RE: Response to TCEQ NOD 3 Addendum – CCR105
Luminant Generation Company LLC – Tatum, Rusk County
Industrial Solid Waste Registration No. 31277
EPA Identification No. TXD000821306
Tracking No. 27220868; RN102583093/CN603256413

Table 1 - NOD Summary and Response
Registration No. CCR105 - Luminant Generation Company LLC
Application Deficiencies - Addendum to NOD 3

RE: Response to TCEQ NOD 3 Addendum – CCR Registration No. CCR105
Martin Lake Steam Electric Station - Rusk and Panola Counties, Texas
(SWR 31277; RN102583093; CN603256413; EPA ID No. TXD000821306)

BEG Study Data Summary

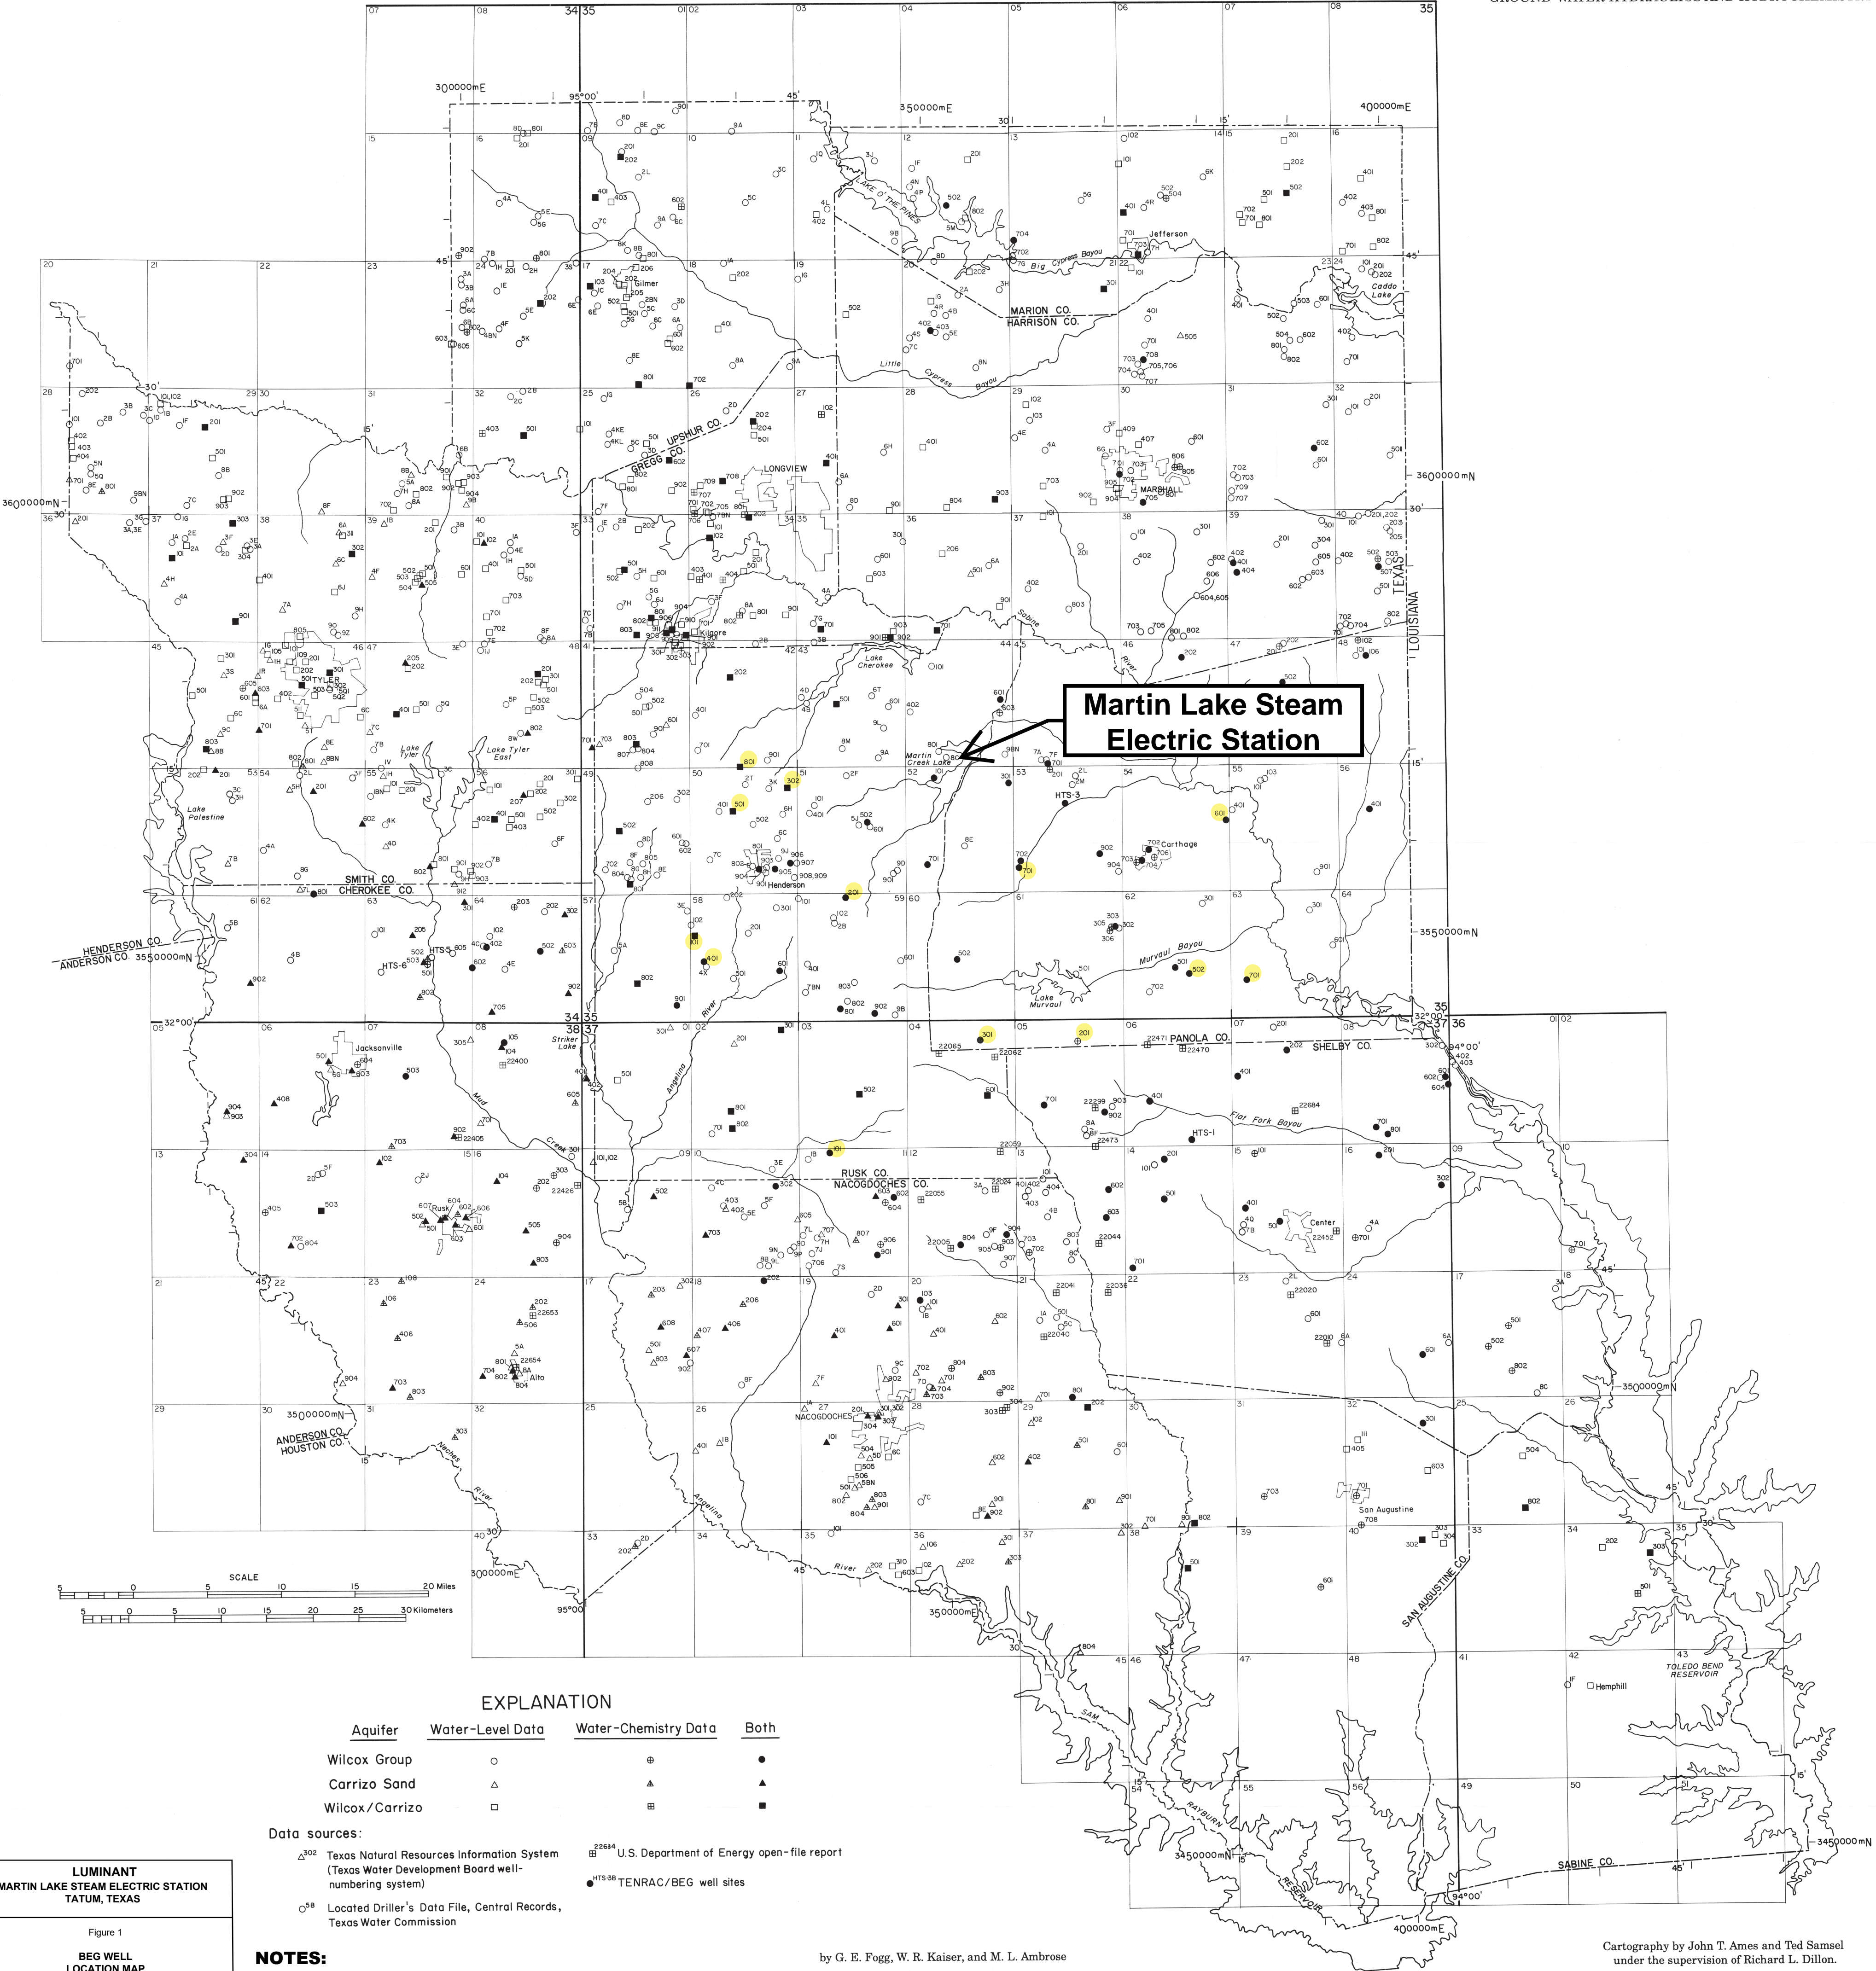
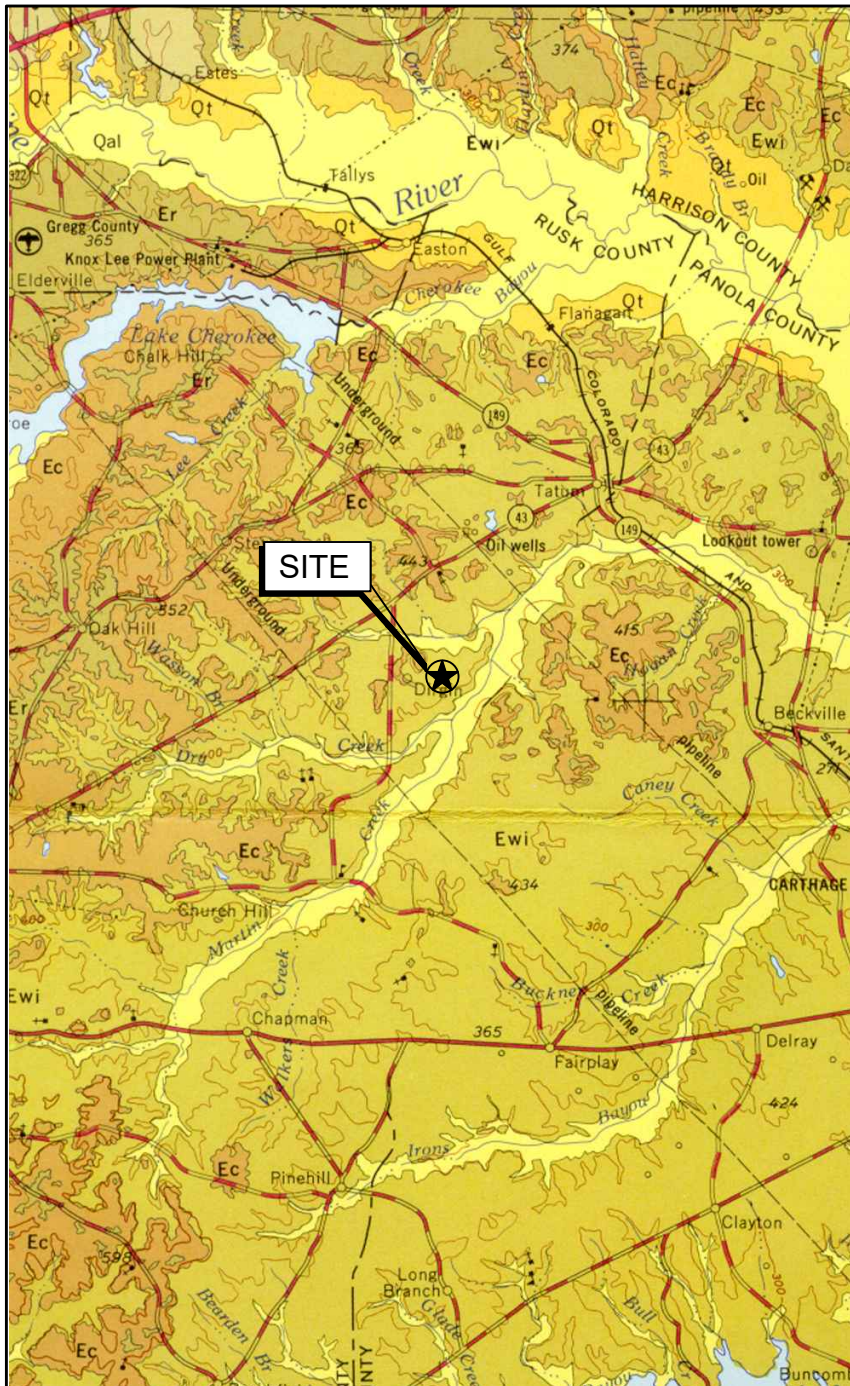
Provide additional water quality data from nearby wells or previous studies that indicate similar concentrations for SSI constituents to support the natural-source explanation within the ASD.

Provide the location of the ASD-referenced sampled wells (distance and direction) in the Sabine uplift area in Texas, as cited in Texas Bureau of Economic Geology report (1991) as stated in the ASD submission.

The groundwater sample data from the BEG study are reproduced in Attachment 6, Table 1. The well location map from the BEG study is reproduced on Attachment 6, Figure 1 with the approximate location of the Martin Lake Steam Electric Station added for reference. Groundwater sample data collected as part of the PDP-5 CCR program were presented in the 2024 Annual Groundwater Monitoring and Corrective Action Report (BBA, 2025b) and in other documents submitted to the TCEQ as part of the CCR unit registration.
